Bull Creek PUD

C814-2009-0139.03 (PUD Amendment)

Leslie Lilly

Planned Unit Development Amendment

BULL CREEK PUD EXHIBIT C LAND USE PLAN

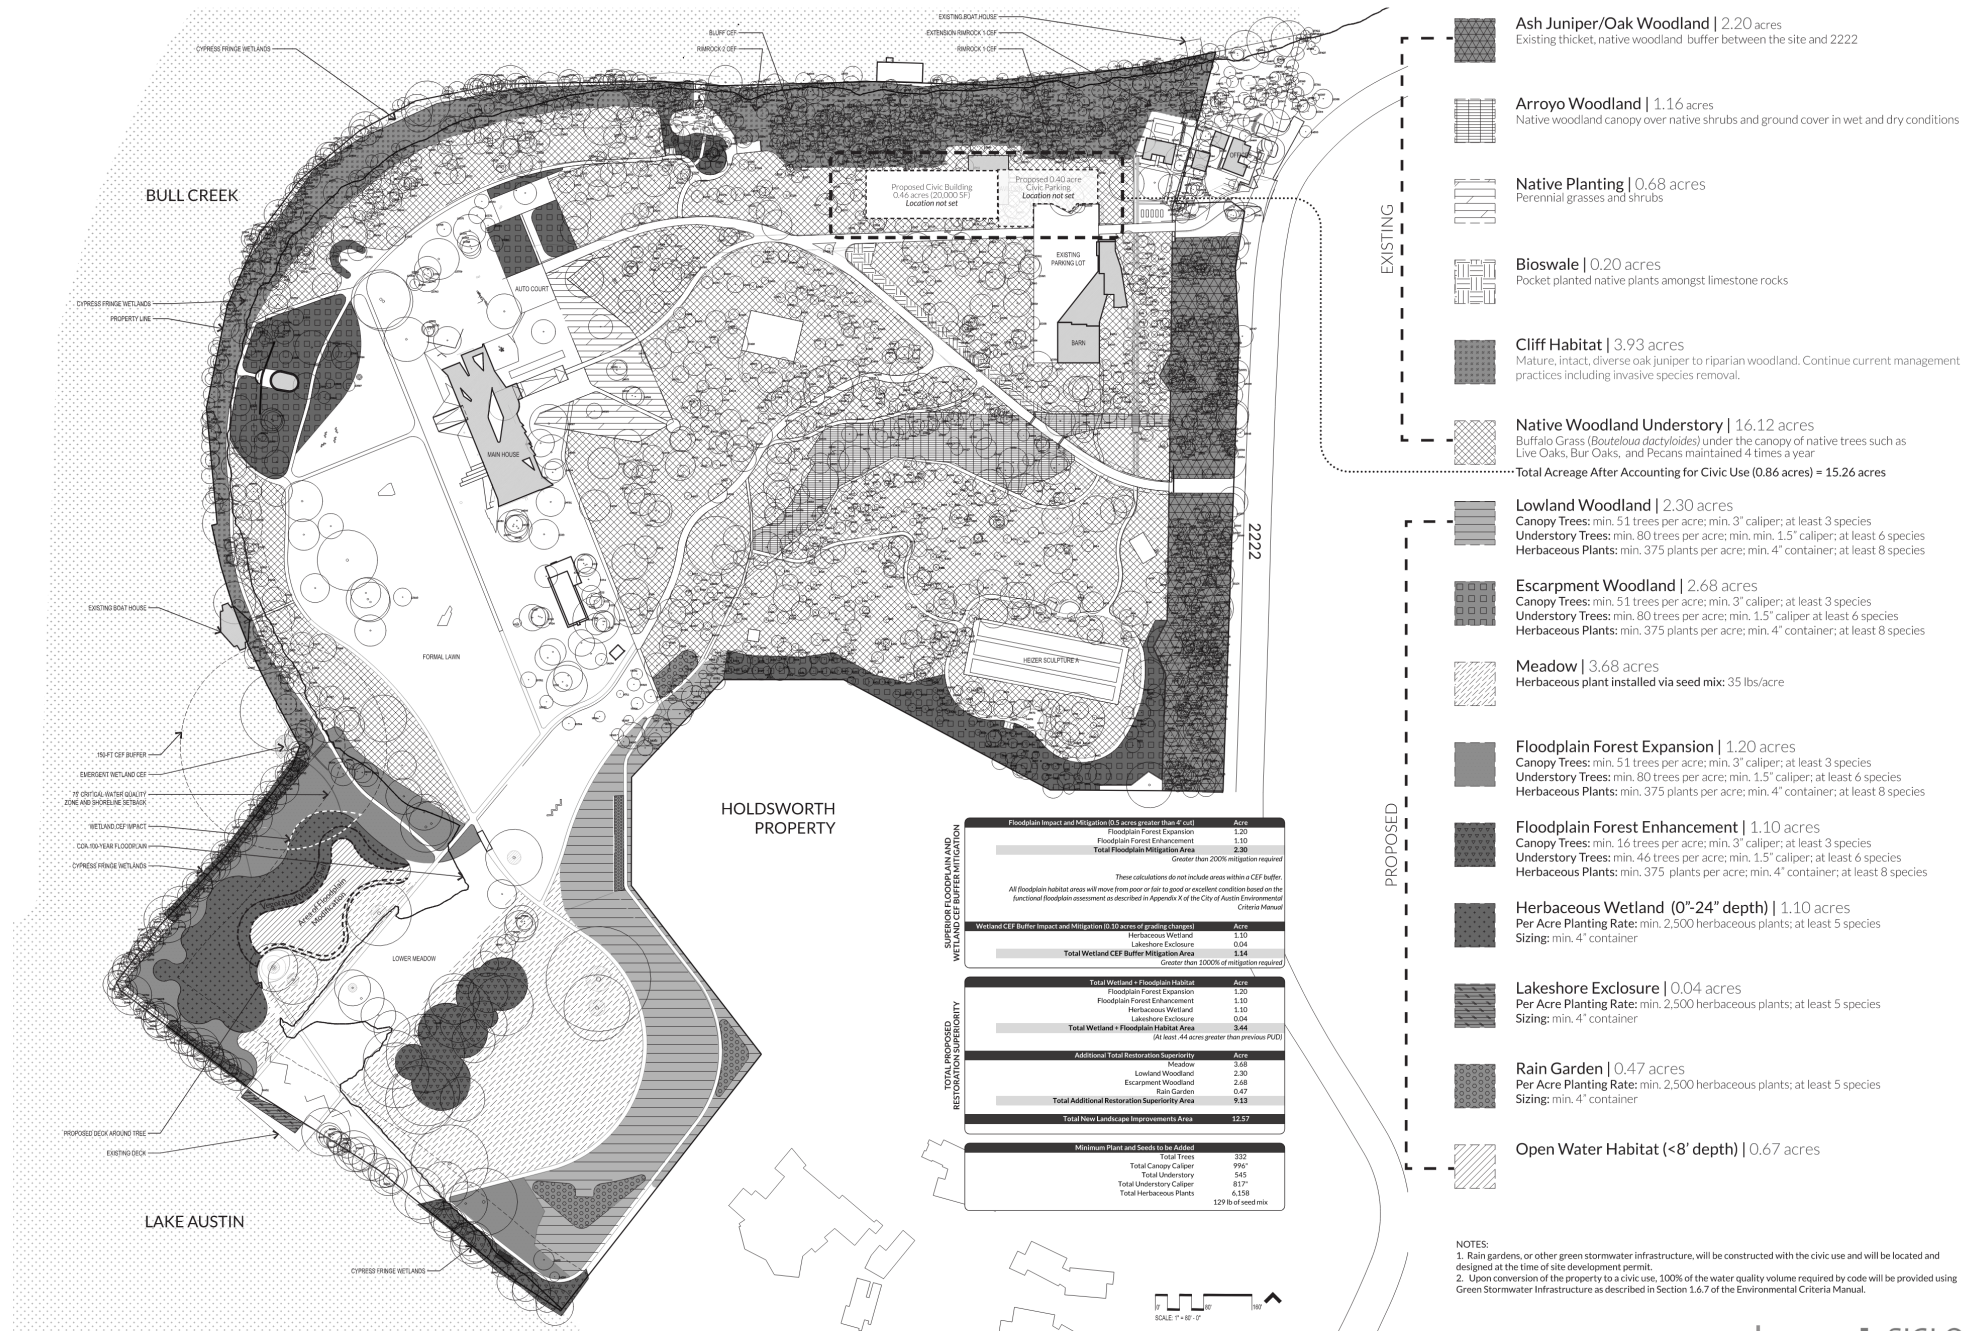
- A Planned Unit Development (PUD) is a type of site development and regulatory process established by city ordinance for a tract of land.
- The Bull Creek PUD was approved by council in 2009, designating the type of development allowed for this single-family residential property.
- The applicant is requesting a PUD Amendment, which includes revising the Land Use Plan (exhibit C) and Restoration plan (exhibit F) for the property.

Staff recommends approval of the PUD Amendment with the following conditions

1. This applicant completes the restoration plan prior to the conversion of the property to civic use as established by the PUD (and referenced in site plan SP-2021-0249D) such that any further development or redevelopment is subject to current code at the time of site development permit application.
2. This project shall comply with 25-8, except for the relevant code modifications included in the PUD amendment.
3. This project shall comply with the environmental superiority elements included in the PUD amendment.
